The
ALTERNATIVE/EXPERIMENTAL WASTEWATER TREATMENT TECHNOLOGIES
TECHNICAL REVIEW COMMITTEE (TRC)

July 13, 2011

Draft Minutes

Orengo Systems, Inc's AX20-RT Request for Equivalency

The MD data is for the Mode 3B configuration in the material Deb provided the TRC for today's meeting (see image on following page).

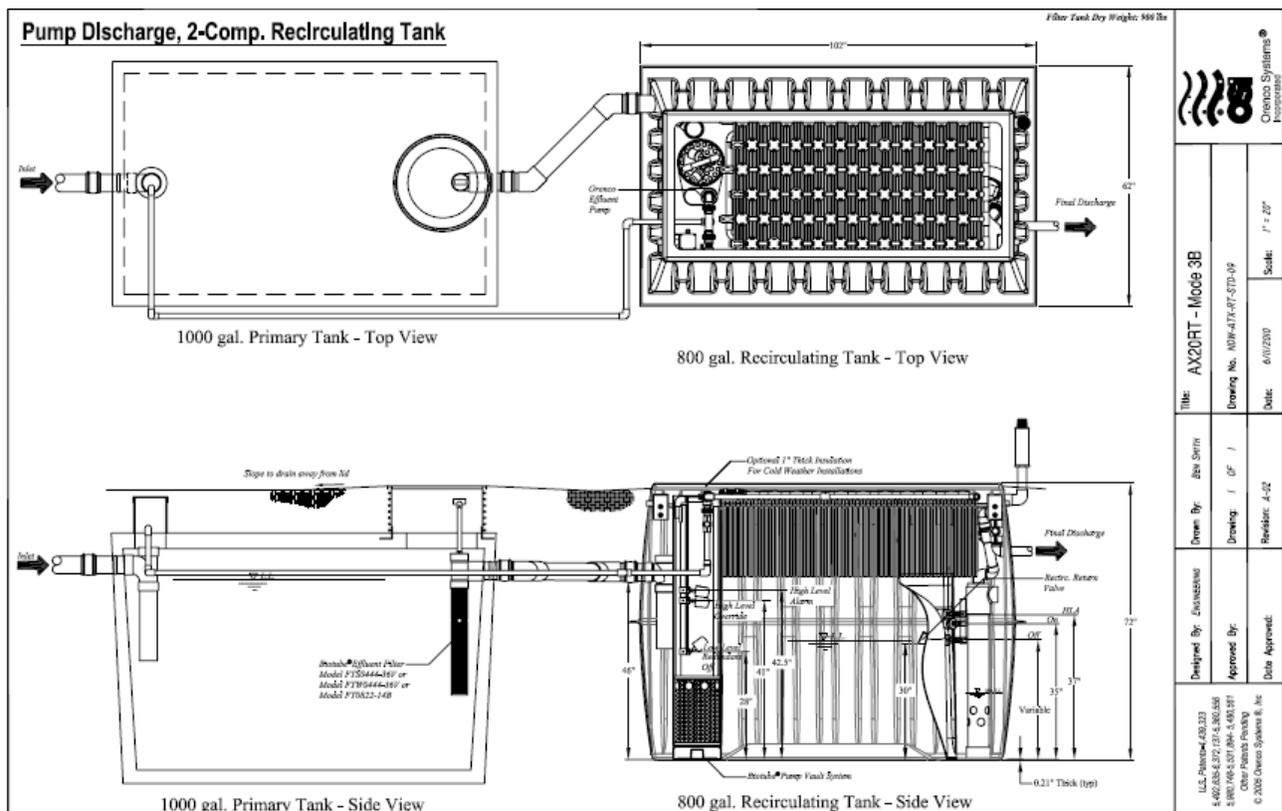
delivered to the media and ½ to the recirculation tank. (However, other than this statement in my notes and my note “Partial Mode 3” on the AX20-RT Mode 3B drawing, I have no detail recorded regarding applicability of Partial Mode 3 and I found nothing on the OSI website regarding this.)

Discussion: George said that at the May 18th presentation at DEM that he got the sense that the RT was still under development and that OSI had not yet decided the final orientation of components in this system. A TRC determination of whether the RT is an equivalent, one-to-one comparison with the AX20 cannot be made by the TRC until they know exactly what the system will look like and have the opportunity to consider data for this specific configuration. Ken asked what RT configuration is in the ground for the data provided. It was stated that the pump is on the inlet side in these systems but that it has been moved to the outlet side for easier O&M.

In Favor: Noel, Dennis, Susan and Ken voted in favor of Noel’s motion to support DEM’s letter to OSI requiring a new technology application with a minimum of two years data for the RT configuration that will be use in RI, or for an experimental application.
